Chief Mechanical & Electrical Engineer
British Railways Board
14 Melbury Terrace
London NW1 6JU

INSTRUCTION

Ref: 172-9-2

GLOUCESTER 3 PIECE BOGIES (CONSTANT FRICTION DAMPING).

DIAGRAM 2.

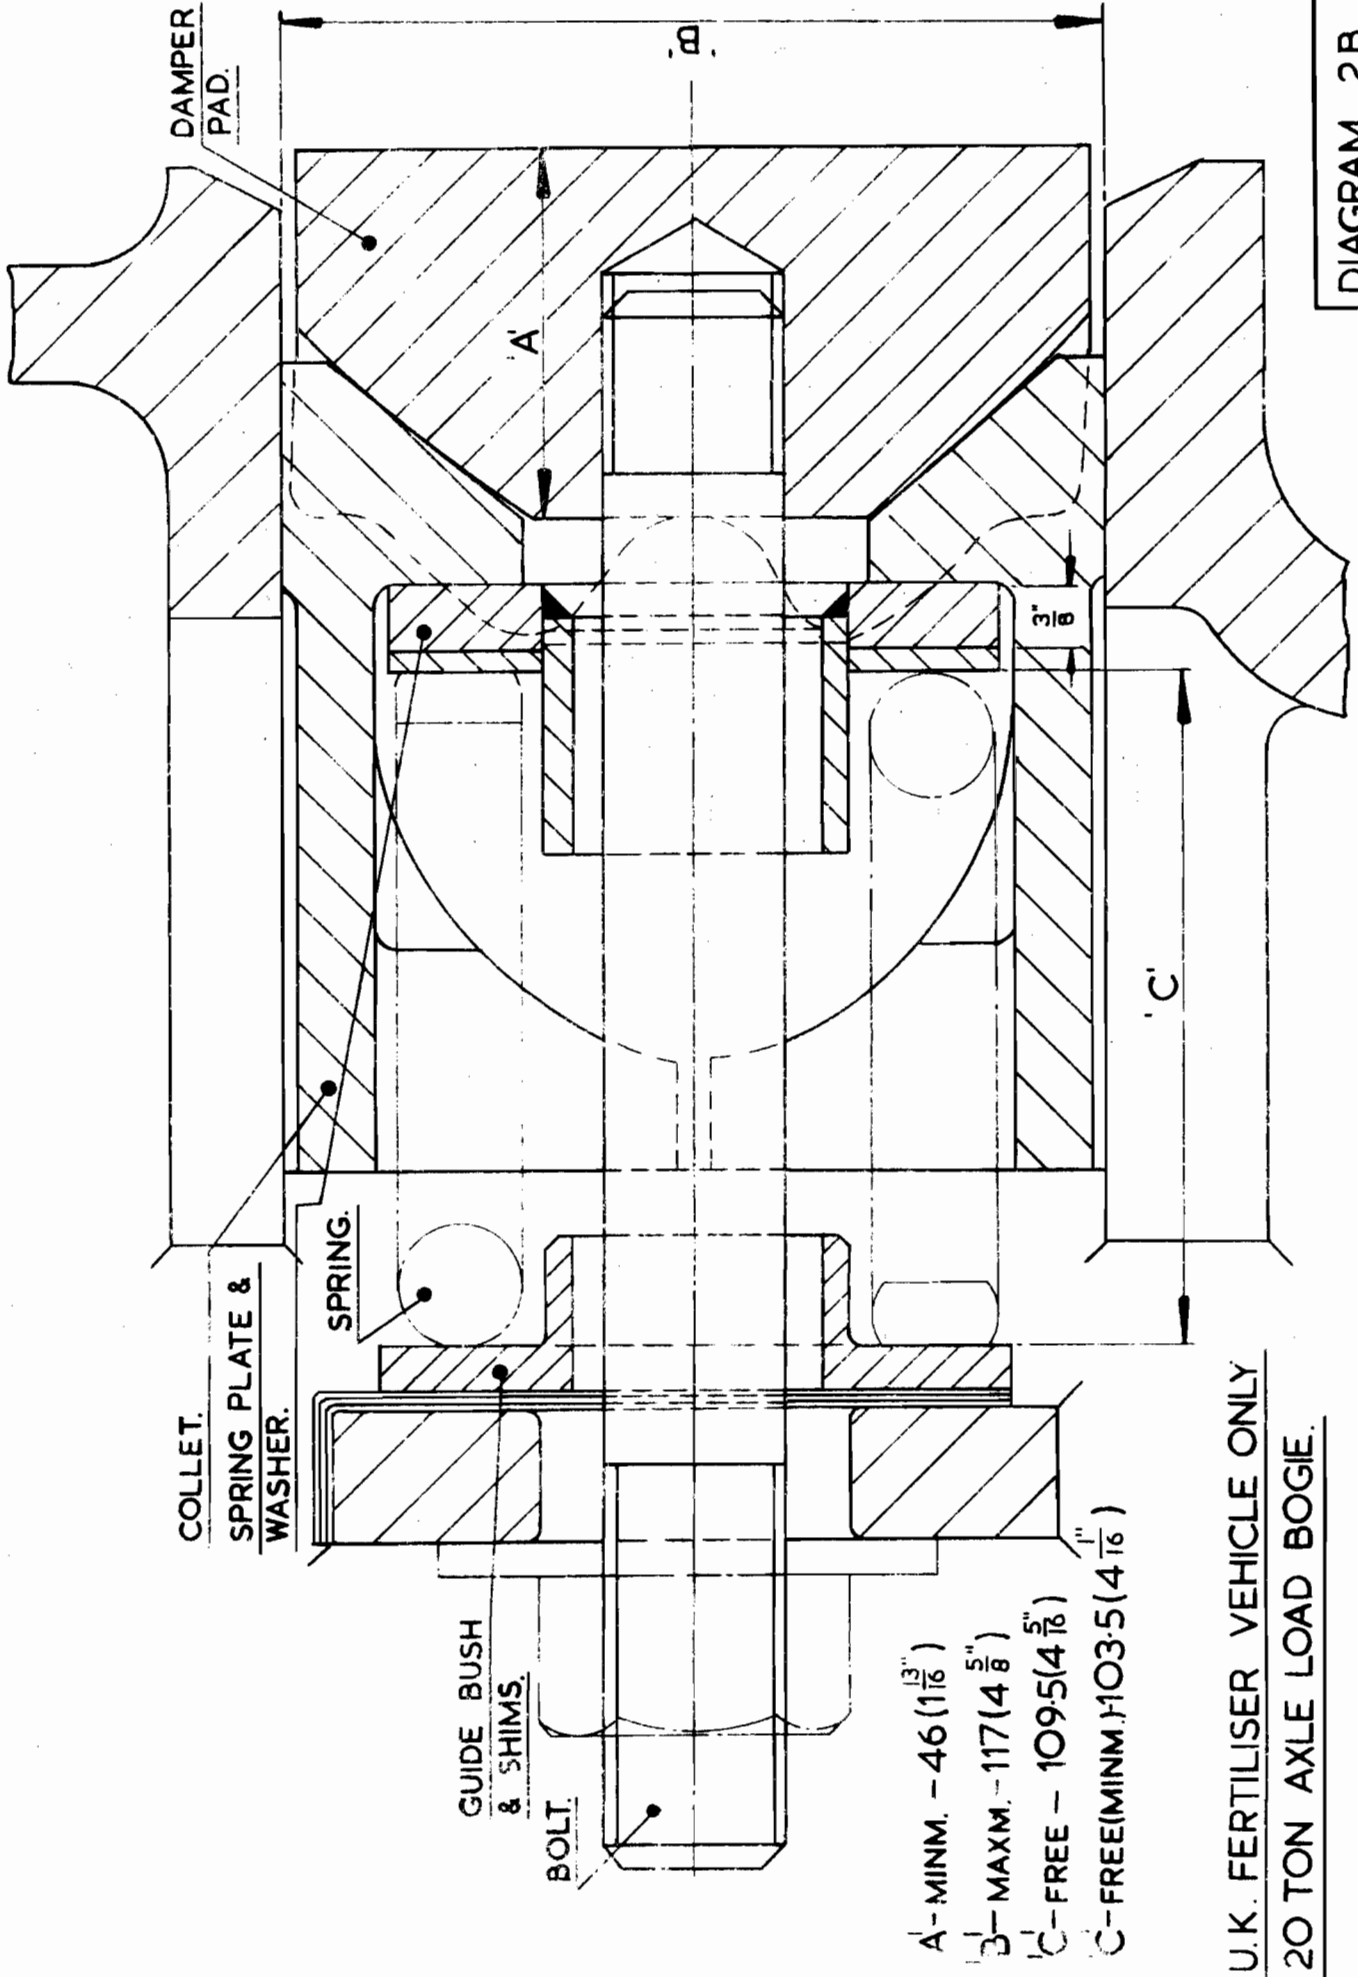
On certain early Gloucester 20 ton axle load bogies the appropriate damper coil spring compression was achieved by inclusion of 1/8" thick loose washers and slotted packing shims (see Diagram 2B). These washers and shims may be missing from the assembly and in such cases they should not be replaced and the 3/8" spring plate should be removed and replaced by a 5/8" spring plate (see Diagram 2).

N.B. It is recommended that this modification is carried out at any classified repair involving stripping of the bogies, irrespective of whether loss of damping has occurred.
